UNITED STATES PATENT AND TRADEMARK OFFICE

APPLICATION NO.	FILING DATE	FIRST NAMED INVENTOR	ATTORNEY DOCKET NO.	CONFIRMATION NO.
10/038,264	01/03/2002	Seungbae Park	EN999048D	8328

Office Action Summary

DETAILED ACTION

FIG. 2

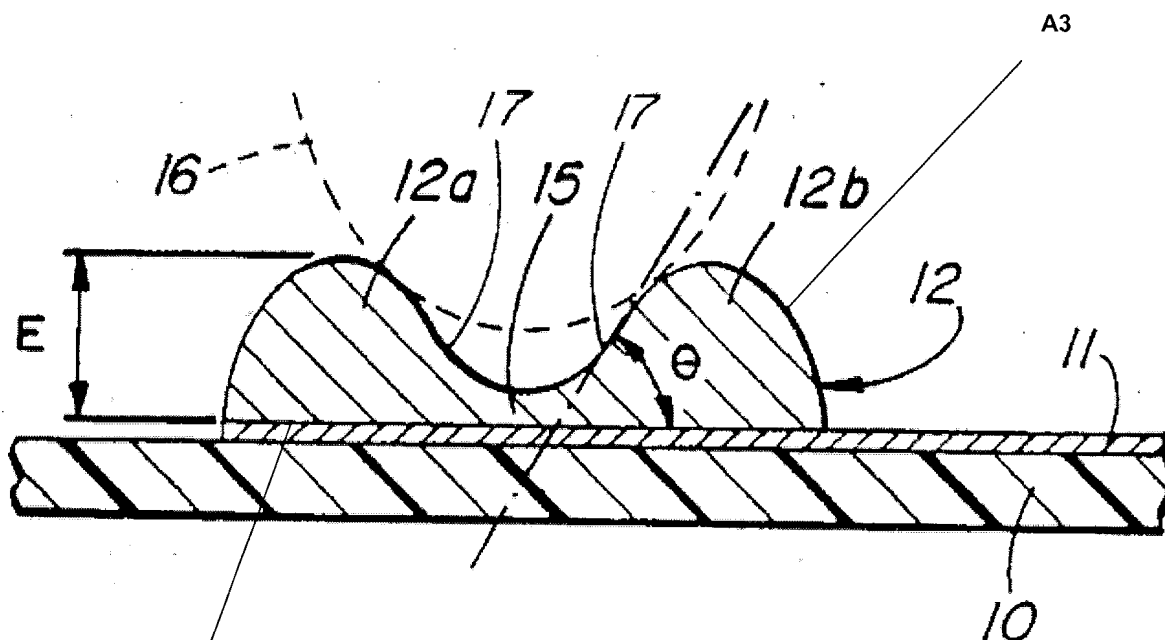
Regarding claim 9, Van Den Brekel et al., disclose, in Figure 2, a solder configuration comprising a pad **12** having a substantially planar lower surface **A2**, and a upper surface **A3**. The upper surface **A3** is characterized as substantially completely

Regarding claim 10, a solder configuration comprising a pad **12** having a substantially planar lower surface **A2**, and an upper surface **A3**. The upper surface **A3** is characterized as substantially completely non-planar serpentine surface. Applicant is reminded that the recitation that an element is "adapted to" perform a function is not a positive limitation but only requires the ability to so perform. It does not constitute a limitation in any patentable sense. *In re Hutchison*, 69 USPQ 138. Therefore, the upper surface can be adapted to receive solder thereby forming a solder boundary portion of a solder joint, the solder boundary portion defining an intermetallic region extending therefrom and penetrating both the solder and the upper surface, whereby, a crack, forming in the solder proximate the solder boundary and within the intermetallic region, is influenced to proceed in a direction substantially parallel to the upper surface along a non-planar, serpentine path, thereby lengthening its travel, and increasing fatigue life of the solder joint.

Regarding claim 16, Van Den Brekel et al., disclose, in Figure 2, an improvement comprising a solder pad **12**, on a substrate **11**, having a substantially planar lower surface **A2** disposed on the substrate **11** and an upper surface **A3** characterized as substantially completely non-planar and circuitous. Applicant is reminded that the recitation that an element is "adapted to" perform a function is not a positive limitation but only requires the ability to so perform. It does not constitute a limitation in any patentable sense. *In re Hutchison*, 69 USPQ 138. Therefore, the upper surface can be adapted to receive solder, such that when solder is applied thereto so as to form a solder joint any crack in the solder proximate the upper surface of the solder pad is influenced to proceed along a path substantially conforming to the non-planar and circuitous upper surface, thereby lengthening its travel, and preventing failure of the solder joint.
